Request for Information (RFI)

Project:	The Big Business District	RFI No :	BD-CW-SAMCO-PCO-RFI-MECH-005
Owner:	ROYA Developments	Rev. :	R06
Project Manager:	ACE-PM	Date :	08 / 03 / 2026
Consultant:	Prime Consultant		
Contractor:	SAMCO National Construction		
To:	PCO

Clarifications Required for Latest Infrastructure Package

LINE 1 (PART 1/3)

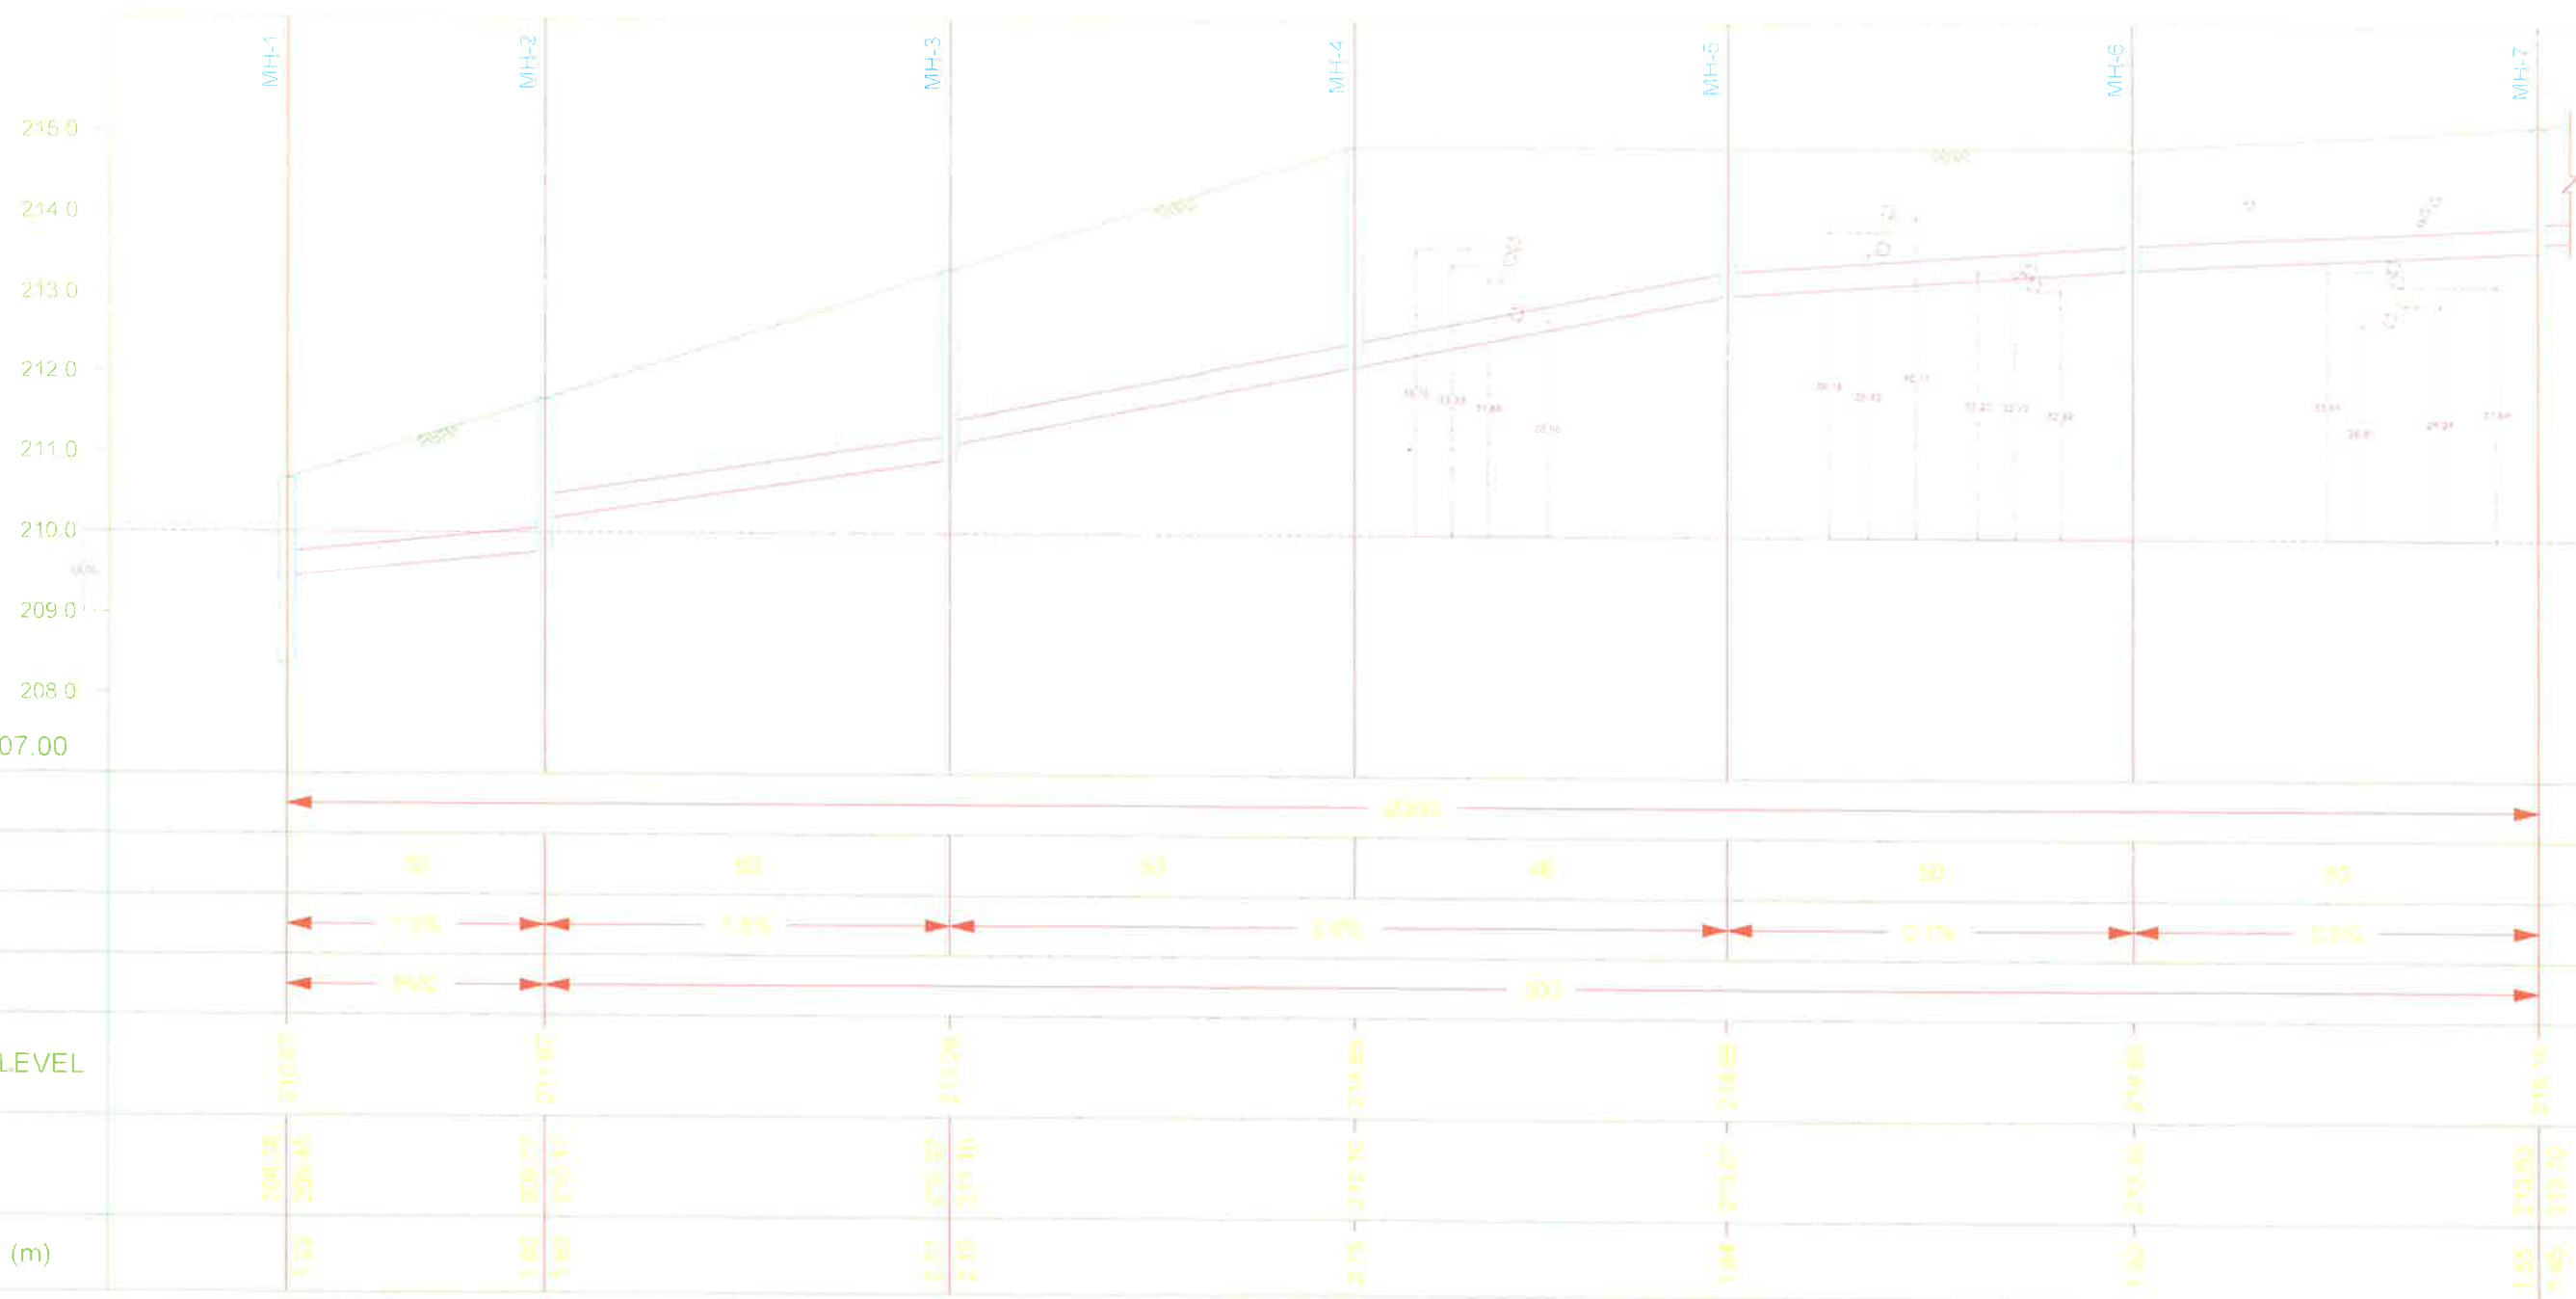
As per the latest infrastructure package, an irrigation line is indicated; however, the exact level and location are not clearly defined. Additionally, it should be noted that this irrigation line was not included in the previously issued mechanical package.

Kindly confirm whether the currently indicated location is final and approved, or if it is subject to modification.

As per the latest infrastructure package, a firefighting line with a diameter of 315 mm is shown exiting the pump room and passing outside the retaining wall.

However, the invert level of this line is not indicated in the drawings.

Regarding the infrastructure drainage lines, it has been observed that the invert levels of some external manholes to which these pipes are intended to connect appear to be higher than the invert levels of the corresponding drainage pipes.

Regarding the water supply line filling the two tanks from the infrastructure network, it has been observed that this line was 110 mm in the latest mechanical package.

However, in the infrastructure package, this line is indicated with a diameter of 200 mm.

Therefore, kindly confirm the exact location and level of this line and also the diameter of the 2 pipes filling the each tank to allow proper coordination and to determine the required sleeves through the retaining wall.

31) Irrigation Line – Level & Location Confirmation: As per the latest infrastructure package, an irrigation line is indicated; however, the exact level and location are not clearly defined. Additionally, it should be noted that this irrigation line was not included in the previously issued mechanical package. Kindly confirm whether the currently indicated location is final and approved, or if it is subject to modification. This clarification is required since the irrigation line location will directly affect the installation of the sleeves / puddle flanges through the water tank walls. Therefore, confirming the final level and location is essential to proceed with the required penetrations and avoid any potential rework.	- Kindly identify drawings number with related dates and issued. - Irrigation line 100mm is a branch from the domestic water pump set discharge header 150mm. - The contractor should be coordinate submitted pump room sleeves location with submitted infrastructure irrigation detailed design drawing through approved shop drawing by the site consultant Engineer. - Kindly coordinate shop drawing works with submitted utility corridor detail design drawing.

32) Firefighting Line from Pump Room – Diameter & Level Clarification: As per the latest infrastructure package, a firefighting line with a diameter of 315 mm is shown exiting the pump room and passing outside the retaining wall. However, the invert level of this line is not indicated in the drawings. Additionally, this line was not shown in the previously issued mechanical package, where only one 150 mm line was indicated to serve Basement 1, Basement 2, and the buildings above. Therefore, kindly clarify the following: Confirm the required level of the 315 mm firefighting line. Confirm whether this line represents a new addition or a revision to the previous design. Confirm the exact location and requirements for the wall penetration. This clarification is required as it will directly affect the sleeve size and location to be provided in the pump room wall.	- Kindly identify drawings number with related dates and issued. - Firefighting line 315mm is the main from the firefighting water pump set discharge header 250mm. - The contractor should be coordinate submitted pump room sleeves location with submitted firefighting detailed design drawing through approved shop drawing by the site consultant Engineer. - Kindly coordinate shop drawing works with submitted utility corridor detail design drawing.

33) Infrastructure Drainage Pipes – Invert Level Coordination: Regarding the infrastructure drainage lines, it has been observed that the invert levels of some external manholes to which these pipes are intended to connect appear to be higher than the invert levels of the corresponding drainage pipes. This condition may prevent proper gravity flow connection to the manholes. Kindly review and clarify the correct invert levels and connection details. This clarification is essential as it will directly affect the location and level of the sleeves required through the retaining wall.	- Kindly identify drawings number with related dates and issued. - The contractor should be coordinate submitted infrastructure drainage with submitted mechanical buildings last issued design drawing through approved shop drawing by the site consultant Engineer. - Kindly coordinate shop drawing works with submitted utility corridor detail design drawing.

4) Water Supply Line Filling the Tanks – Location & Level Confirmation: Regarding the water supply line filling the two tanks from the infrastructure network, it has been observed that this line was 110 mm in the latest mechanical package. However, in the infrastructure package, this line is indicated with a diameter of 200 mm. Therefore, kindly confirm the exact location and level of this line and also the diameter of the 2 pipes filling the each tank to allow proper coordination and to determine the required sleeves through the retaining wall.	- Kindly identify drawings number with related dates and issued. - The contractor should be coordinate submitted infrastructure water supply with submitted mechanical buildings last issued design drawing through approved shop drawing by the site consultant Engineer. - Infrastructure main filling line 200mm Parcel 2 tanks with branches at each inlet tanks 100mm - Kindly coordinate shop drawing works with submitted utility corridor detail design drawing.
